PROJECT TITLE:
GARDEN HILL FIRST NATION +
WASAGAMACK FIRST NATION
HOUSING PROJECT
STREET NAME AND NUMBER
CITY, PROVINCE, POSTAL CODE

DRAWING TITLE:
FLOOR PLAN

A-1
SHEET 1 OUT OF 06

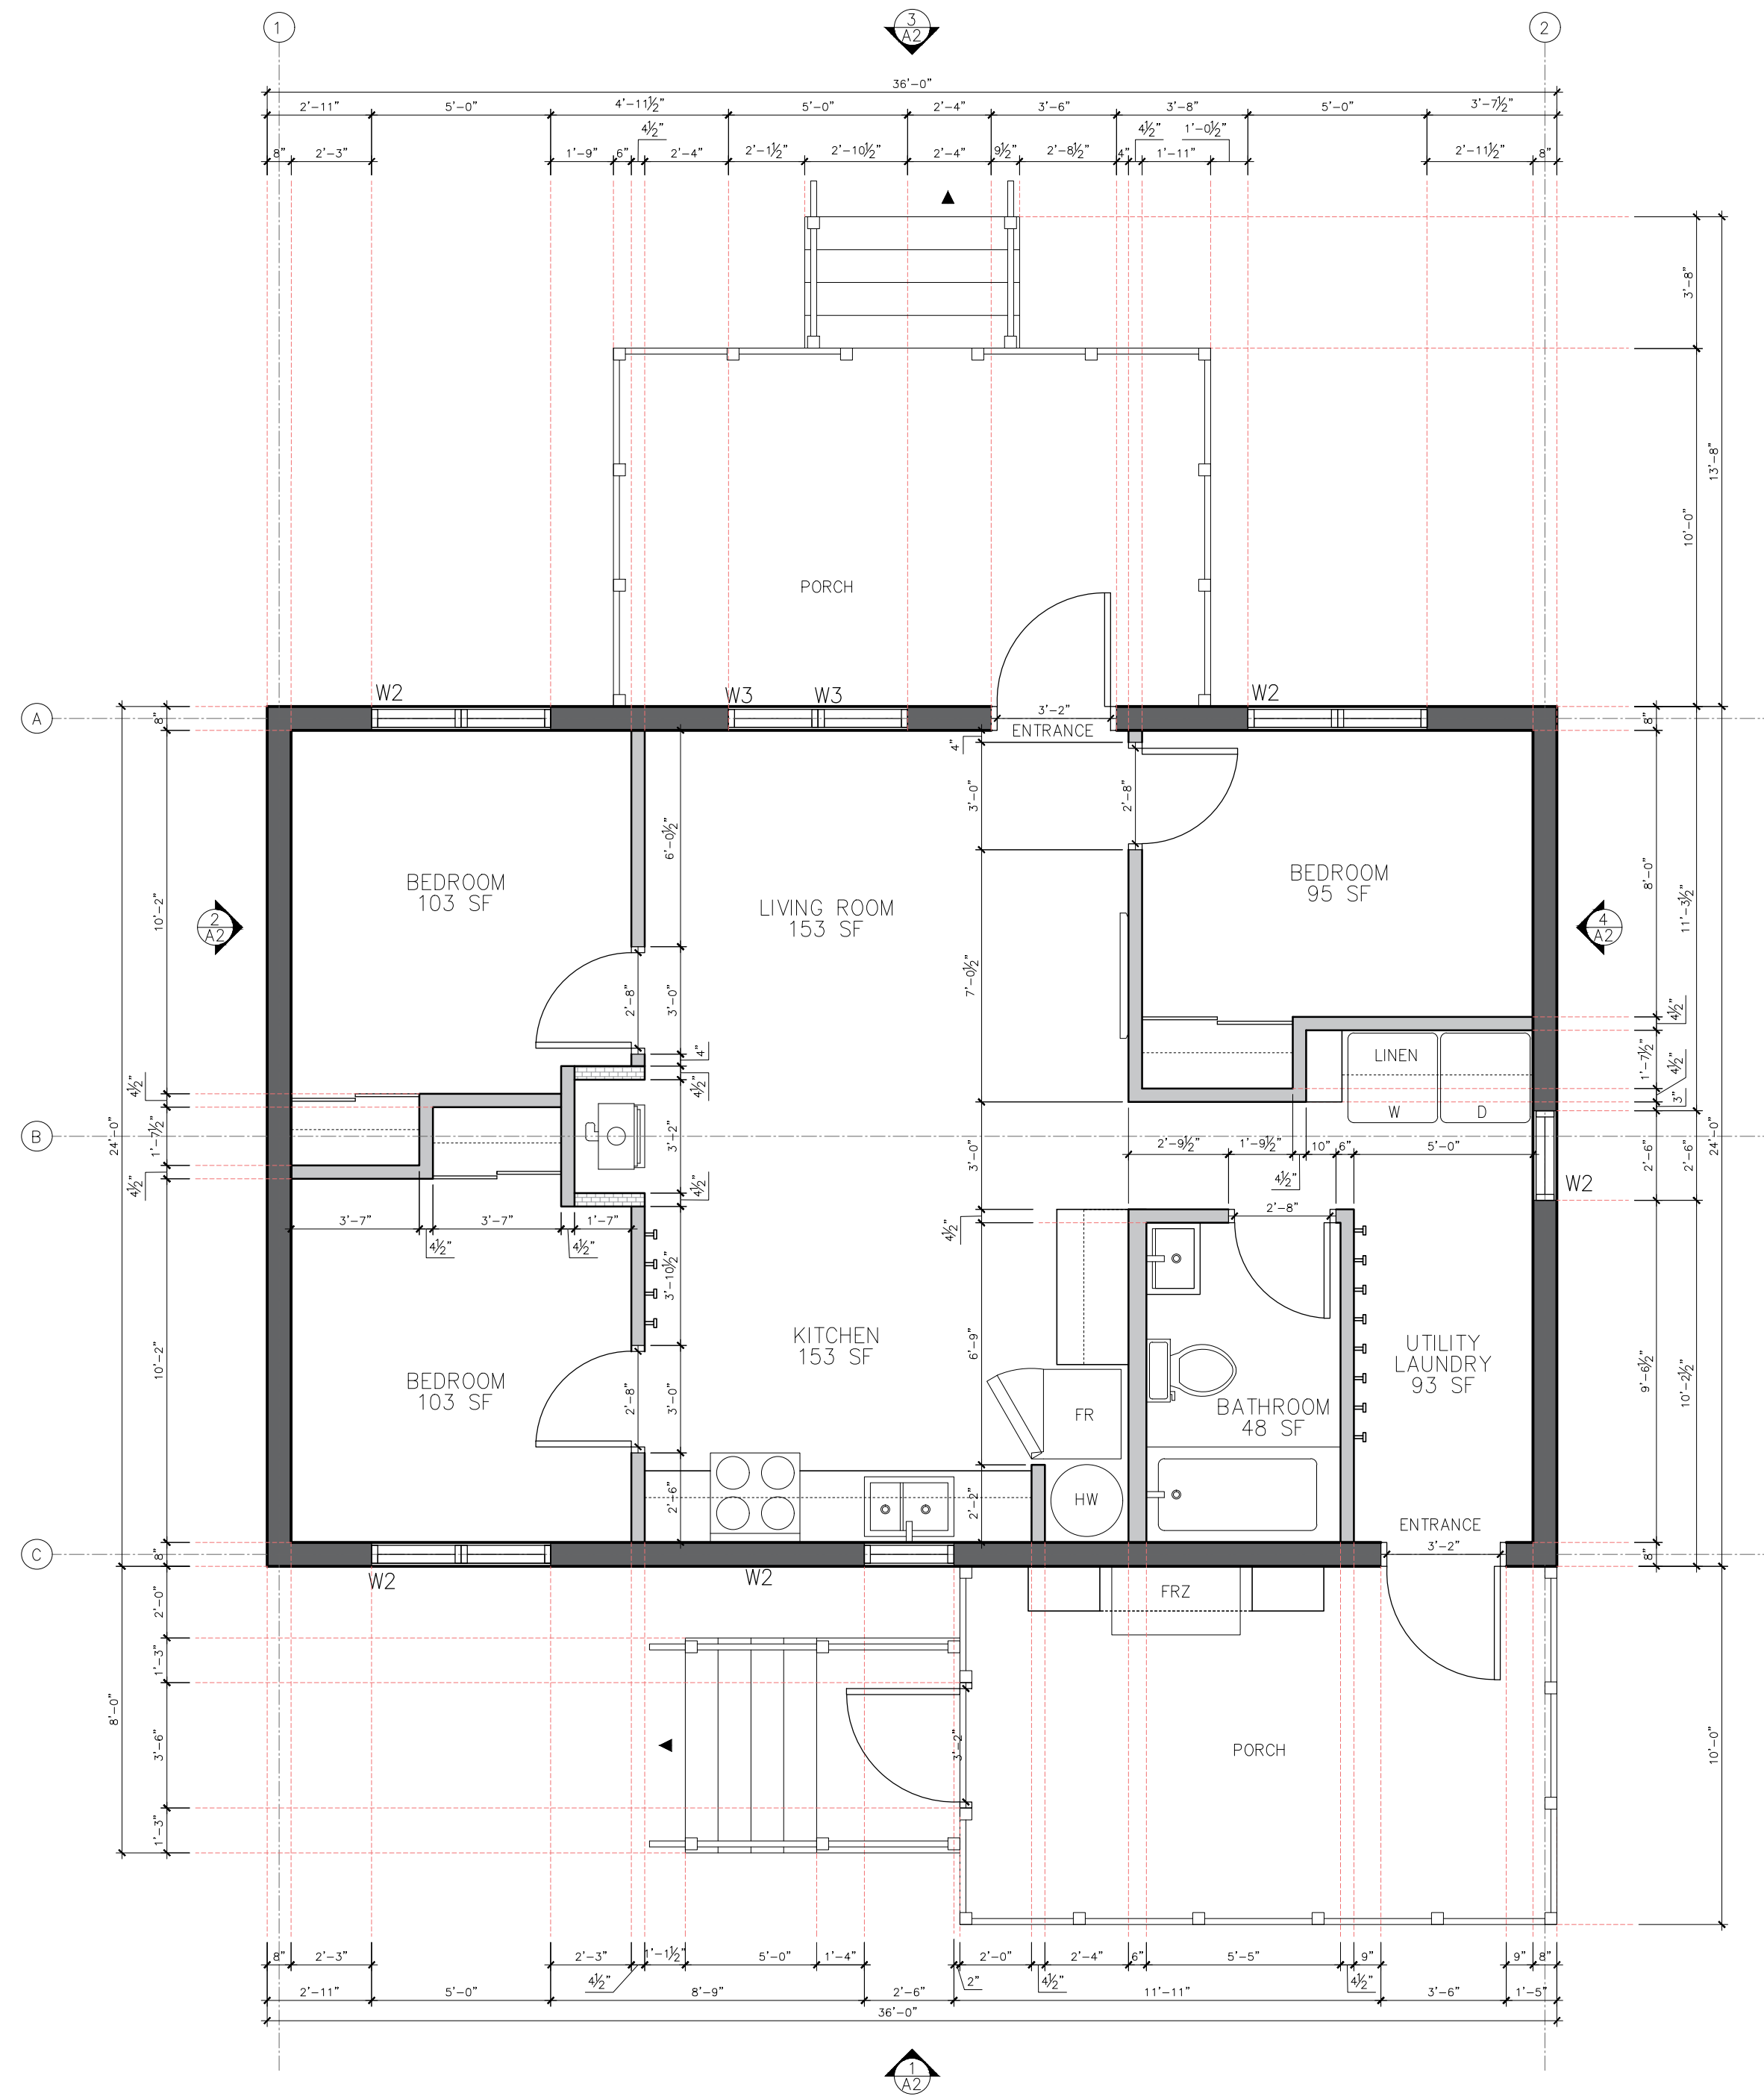
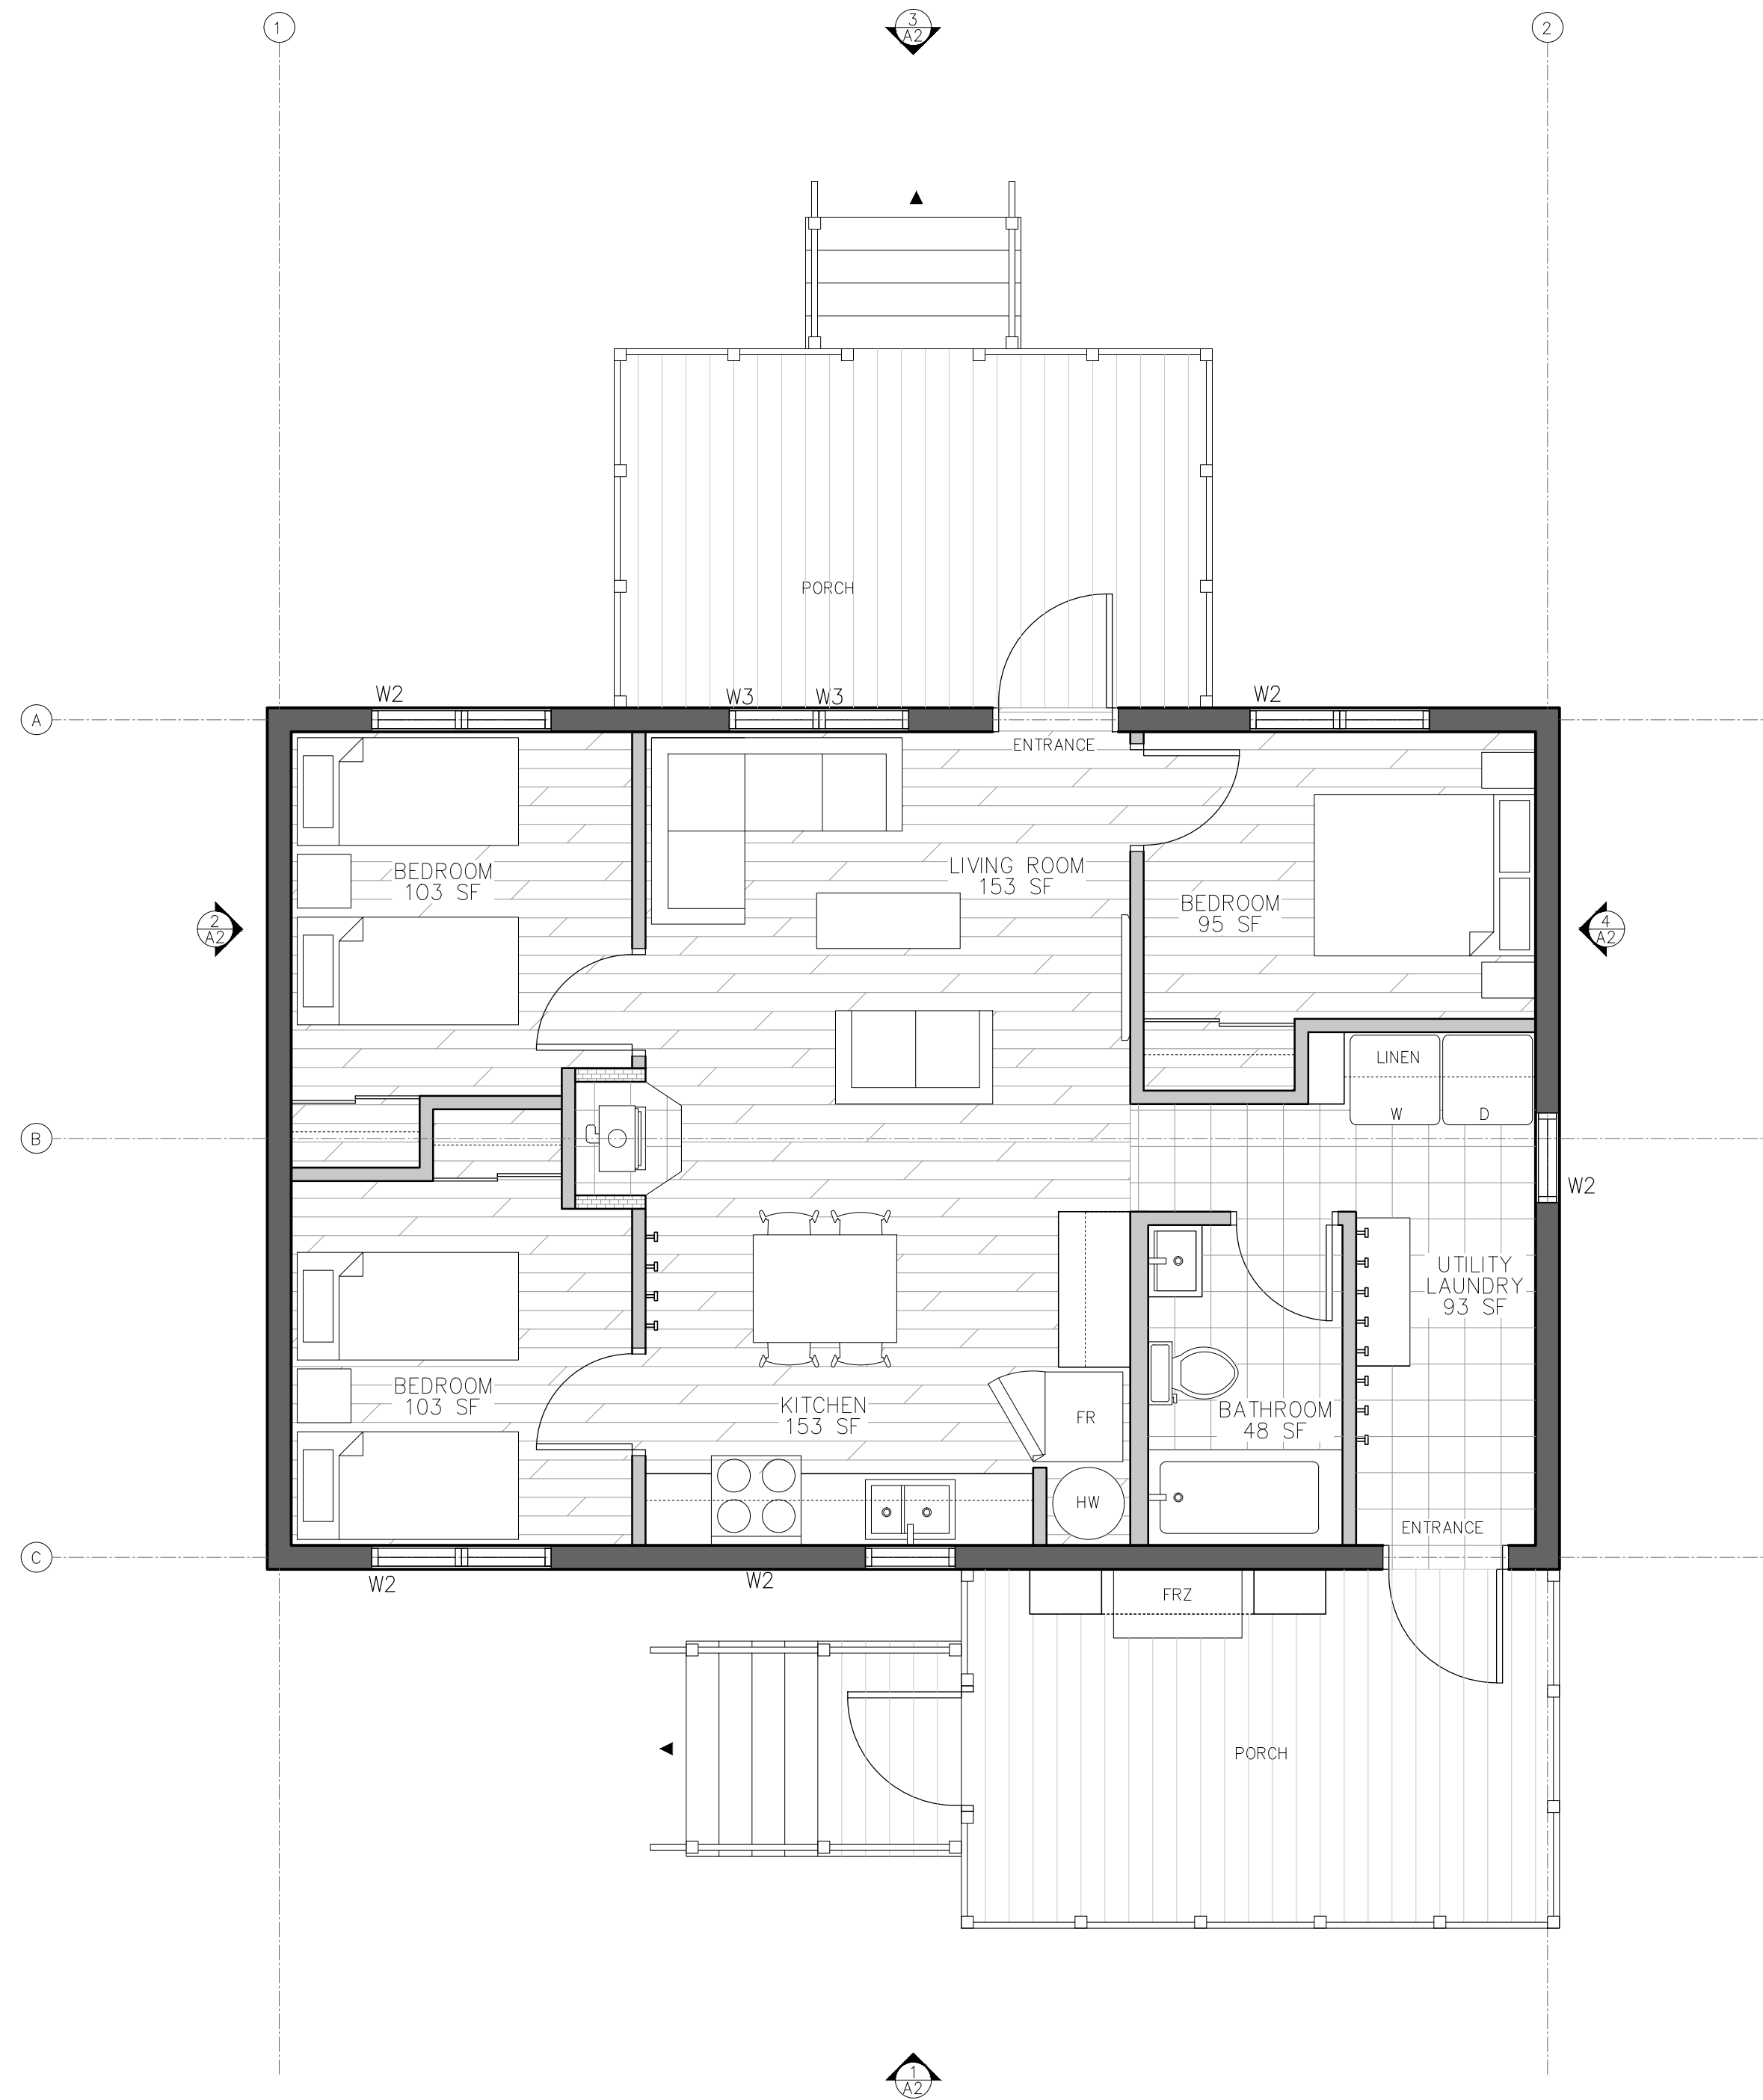
- CONSTRUCTION OF ENCLOSED VERTICAL CHASE
 - ON PACKED GRAVEL?
 - HOW TO INSULATE?
- STRUCTURAL LOAD CALCULATION MUST BE DONE. ADJUSTMENTS SHOULD BE MADE.
- ROOF AND CEILING ASSEMBLY.
- CHIMNEY AND MASONRY INTERIOR WALLS HAVE NOTE BEEN DETAILED.
 - PLEASE TAKE A LOOK AND DETAIL AS APPROPRIATE.
